HISTORIC AND DESIGN REVIEW COMMISSION

October 20, 2021

HDRC CASE NO: 2021-509
ADDRESS: 911 N PINE ST
LEGAL DESCRIPTION: NCB 531 (PINE AT HAYS {IDZ}), BLOCK 13 LOT 25
ZONING: IDZ, H
CITY COUNCIL DIST.: 2
DISTRICT: Dignowity Hill Historic District
APPLICANT: Llyas Salahud-din
OWNER: SA URBAN HOMES LLC
TYPE OF WORK: Addition of staircase, amendment to previously approved carport, extension of previously approved deck
APPLICATION RECEIVED: September 28, 2021
60-DAY REVIEW: Not applicable due to City Council Emergency Orders
CASE MANAGER: Edward Hall
REQUEST:

SITE PLAN BUILDING 1

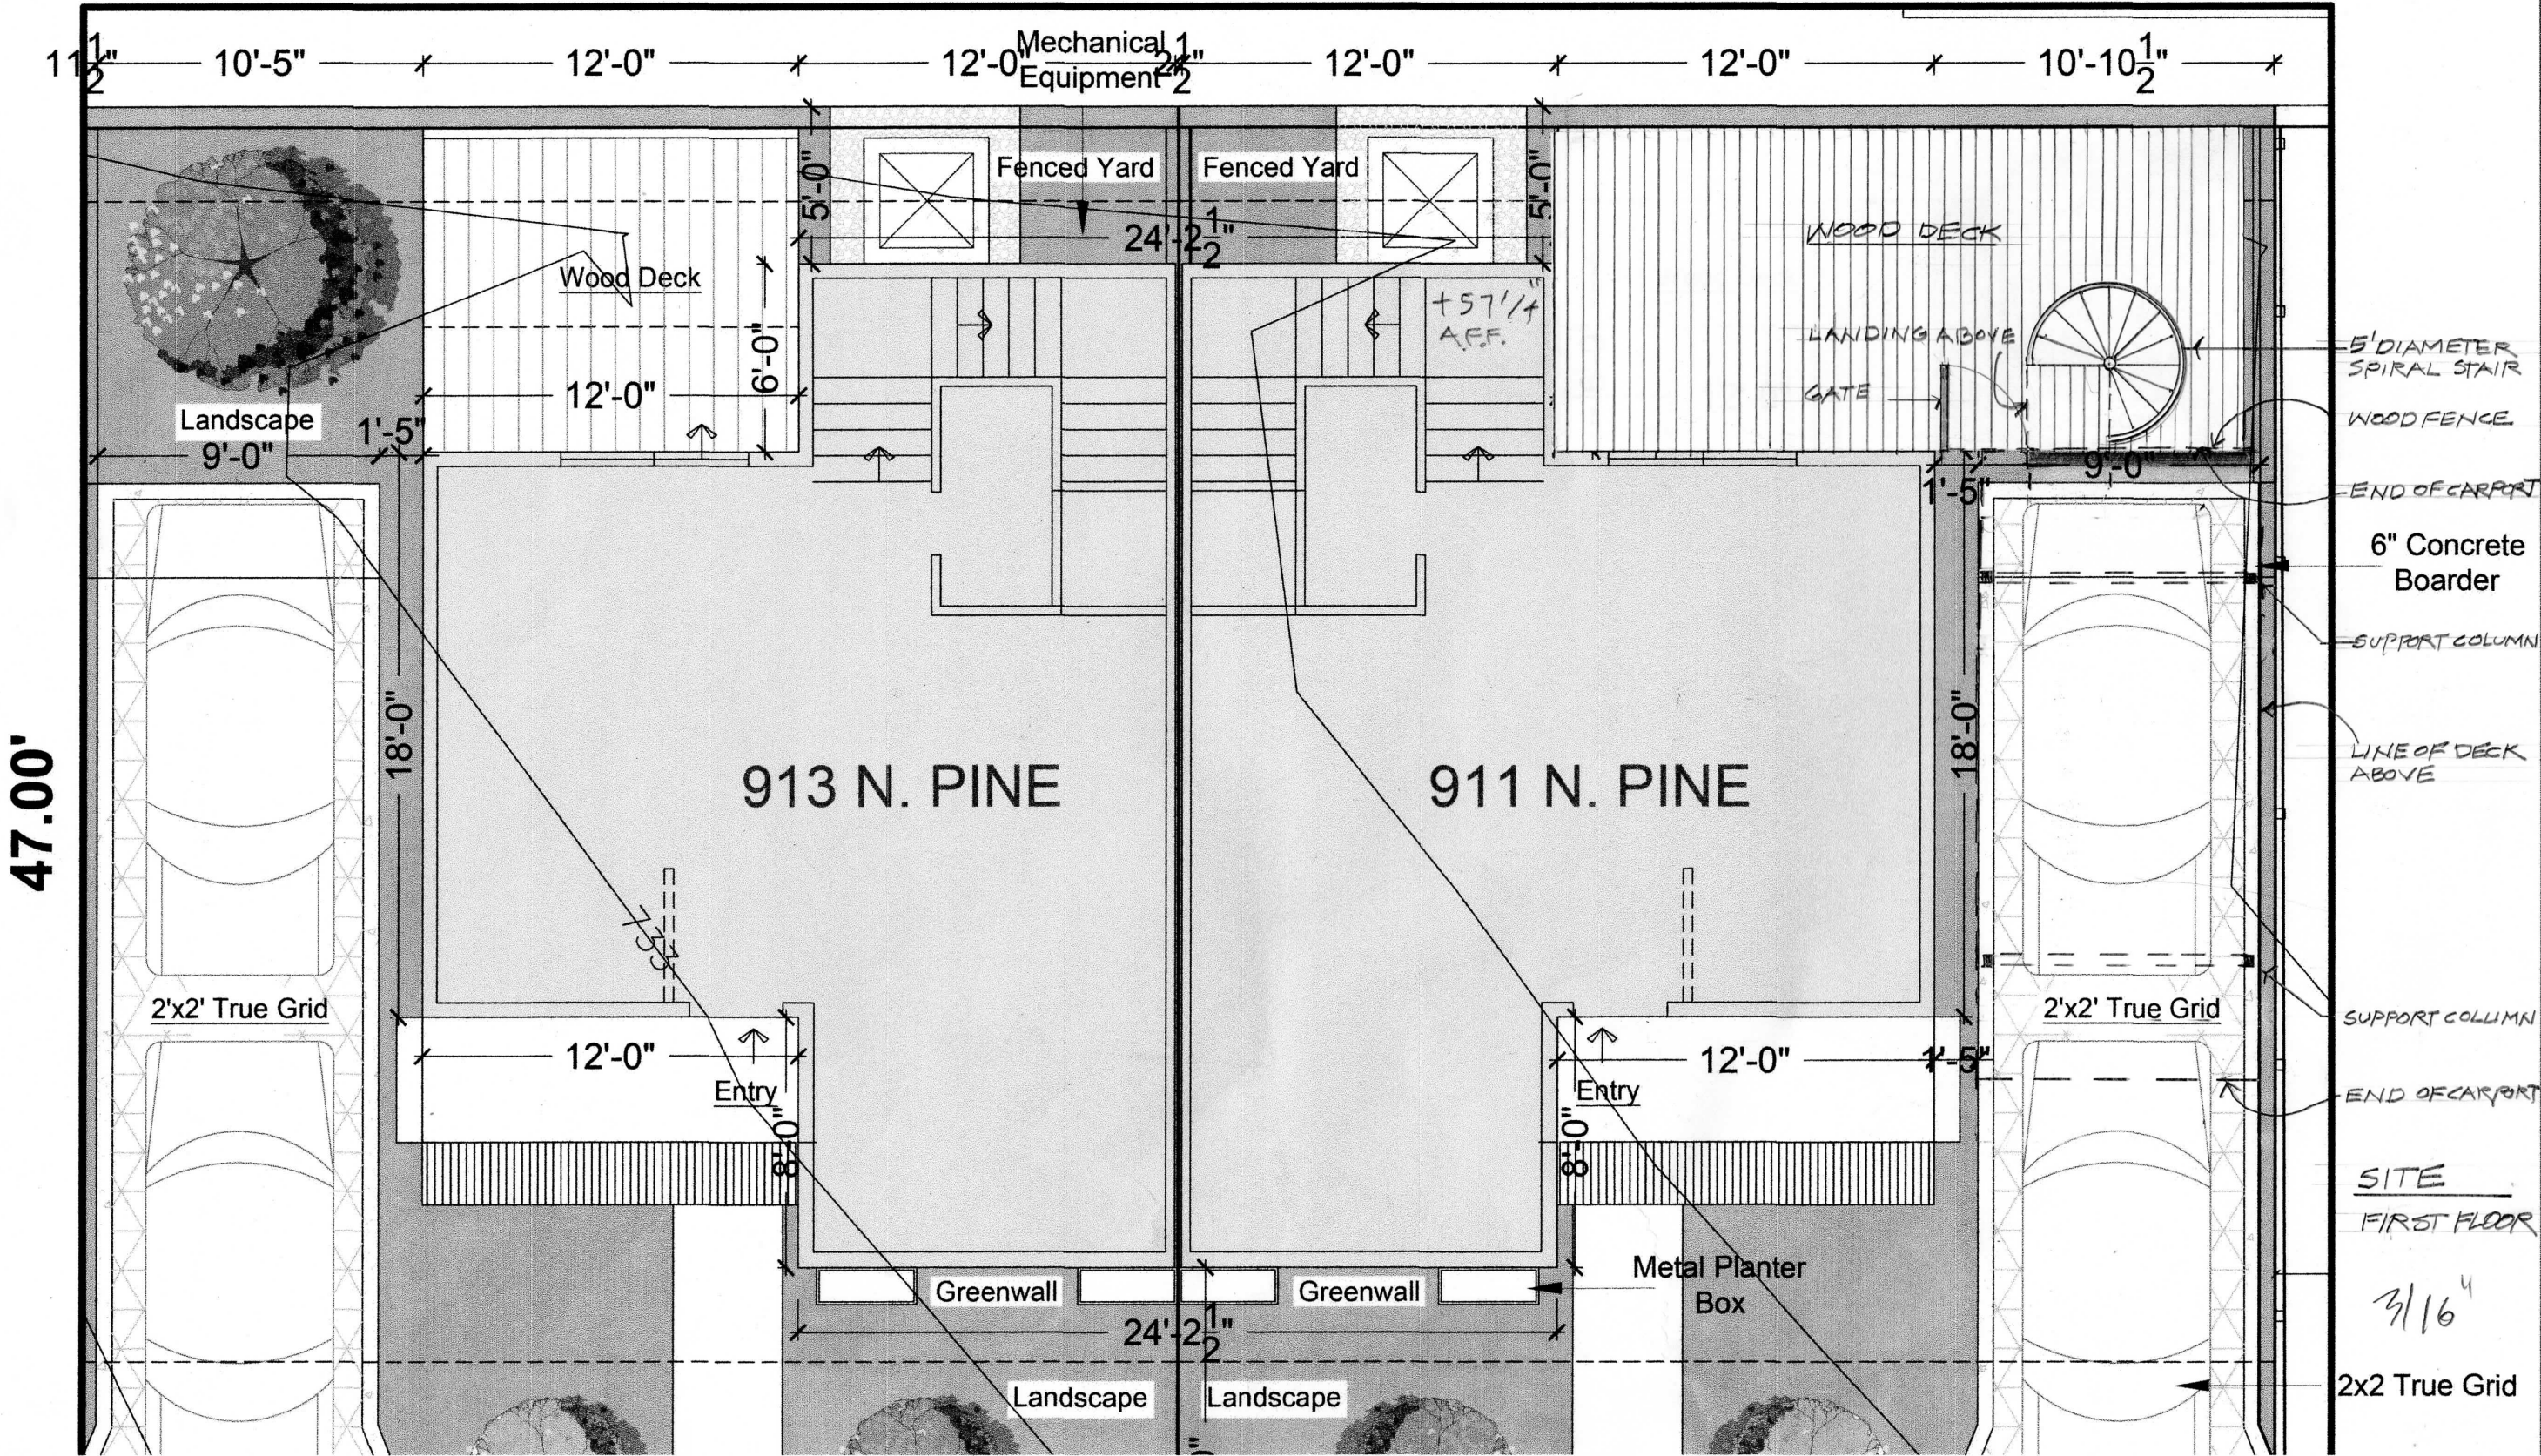
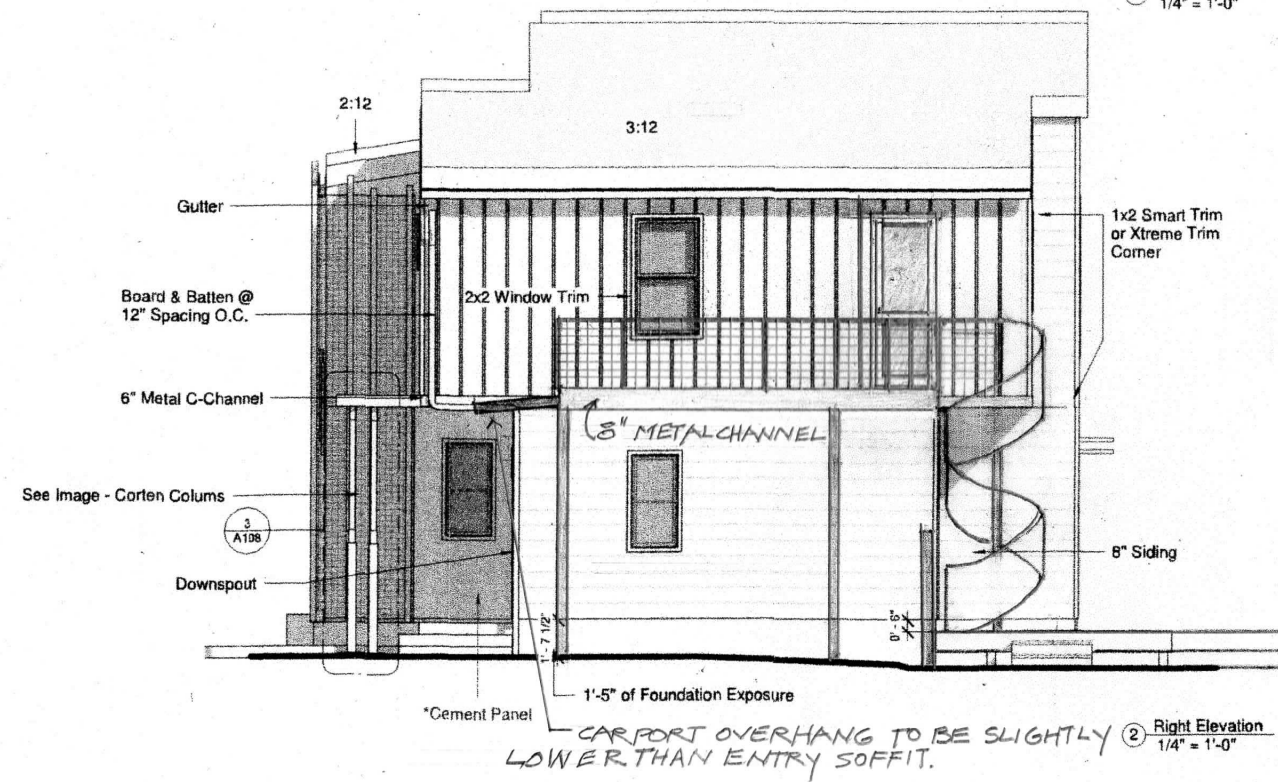
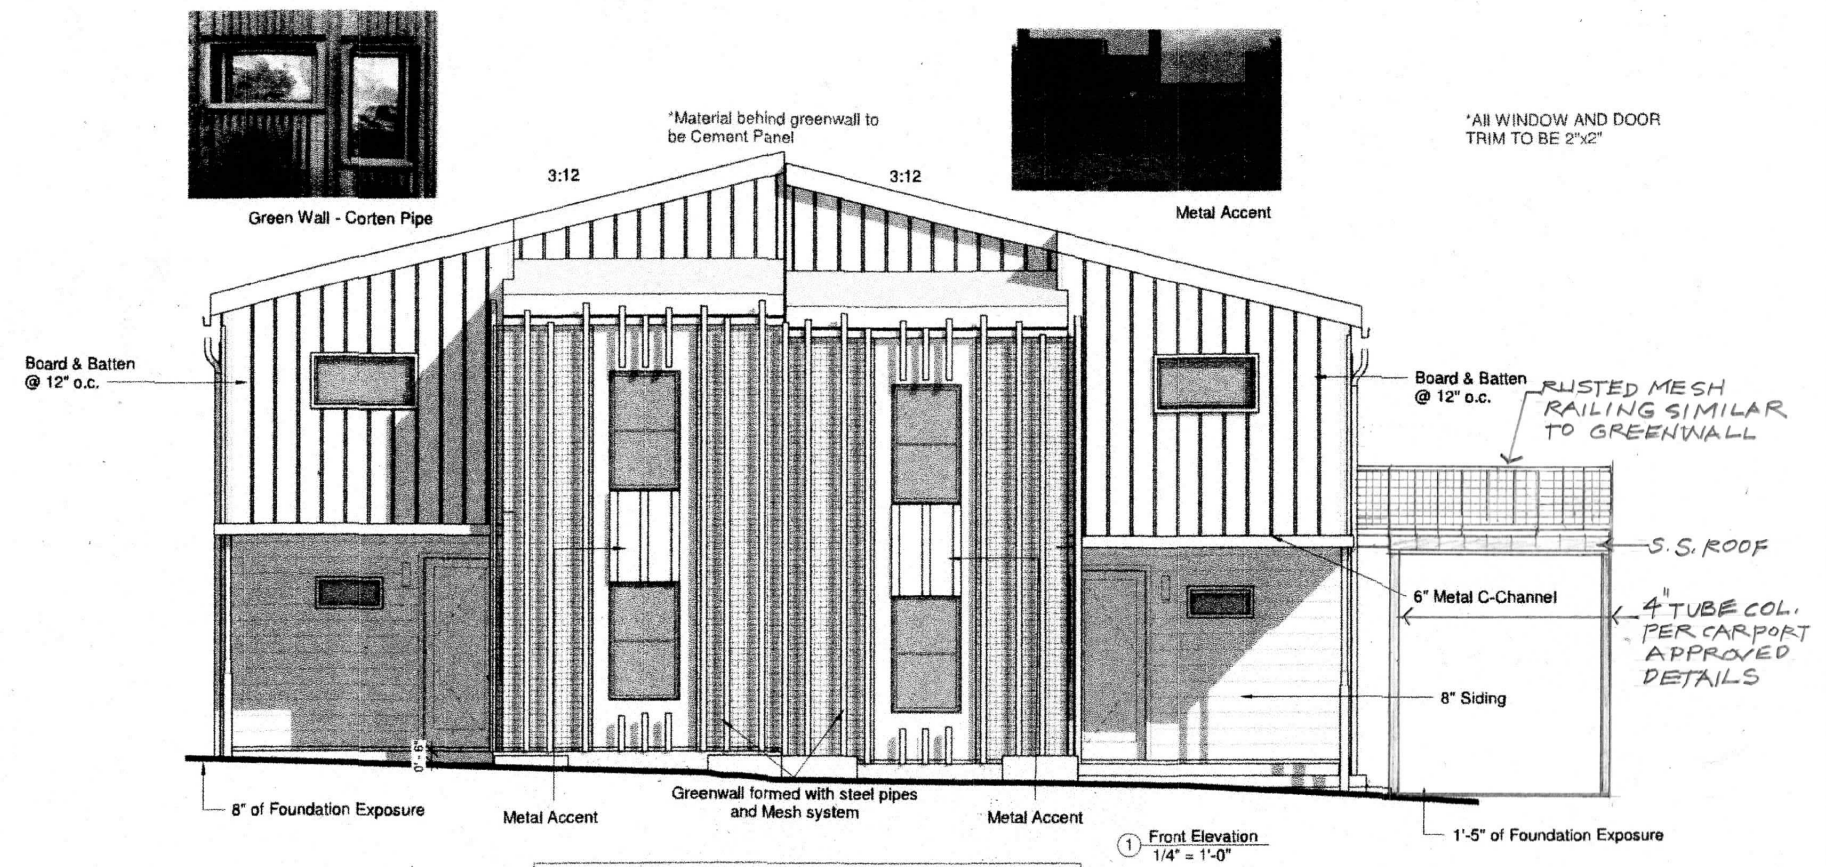
- a. The applicant is requesting a Certificate of Appropriateness for approval to modify the previously approved deck and carport design at 911 N Pine, new construction located within the Dignowity Hill Historic District. The new construction at 911 – 917 N Pine was approved by the Historic and Design Review Commission on August 19, 2020. The previously approved carports were approved as a separate request on April 21, 2021.
- b. **REAR DECK** – The applicant has proposed to extend the previously approved ground level deck by approximately eleven (11) feet to the east. Generally, staff finds this request to be appropriate.

- c. **SECOND LEVEL DECK/CARPORT (Massing)** – The applicant has proposed to construct a second level deck onto the east (side elevation) to feature a spiral staircase and covered parking. This structure will double as a carport. The Guidelines for New Construction 5.A. note that new accessory structures should be designed to be visually subordinate to the primary historic structure on the lot in terms of their height, massing and form; and should be no larger than forty (40) percent of the primary historic structure’s footprint. The applicant has proposed both a footprint and an overall height that is subordinate to that of the primary structure and is consistent with the Guidelines. As noted in finding a, the Historic and Design Review Commission approved the construction of a detached carport. The previously approved carport featured a similar footprint with a shorter height. The previously approved carport was completed detached from the new construction, but featured a consistent setback to the side and rear property lines. Staff finds that the proposed carport should be detached from the primary structure.

- e. **SETBACKS & ORIENTATION** – The Guidelines for New Construction 5.B. note that the predominant garage orientation found along the block should be matches. Additionally, the Guidelines note that setbacks of new accessory structures should be similar to the setbacks of those found historically in the district. Staff finds the proposed carport structures to be sited consistently with the Guidelines.

- 1. Staff recommends approval of item #1, the extension of the existing deck as submitted, based on finding b.
- 2. Staff recommends approval of item #2, the construction of a second level deck and carport, based on findings c and d with the following stipulations:
 - i. That proposed standing seam metal roof should feature smooth panels that are 18 to 21 inches wide, seams that are 1 to 2 inches in height and a standard galvalume finish. A crimped ridge seam is to be used and if a ridge cap is requested, it must feature a low profile and be approved by staff prior to installation.
- 3. Staff recommends approval of item #3, the replacement of a window with a wood door, based on finding f.

SIDE ELEVATION

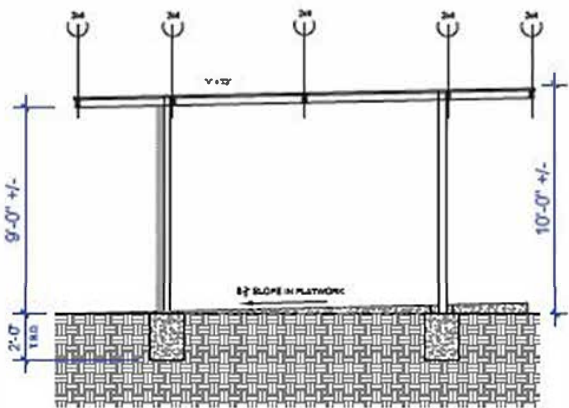
- f. **WINDOW MODIFICATION** – The applicant has proposed to install a wood door where a window was previously approved. Generally, staff finds the proposed modification to be appropriate.
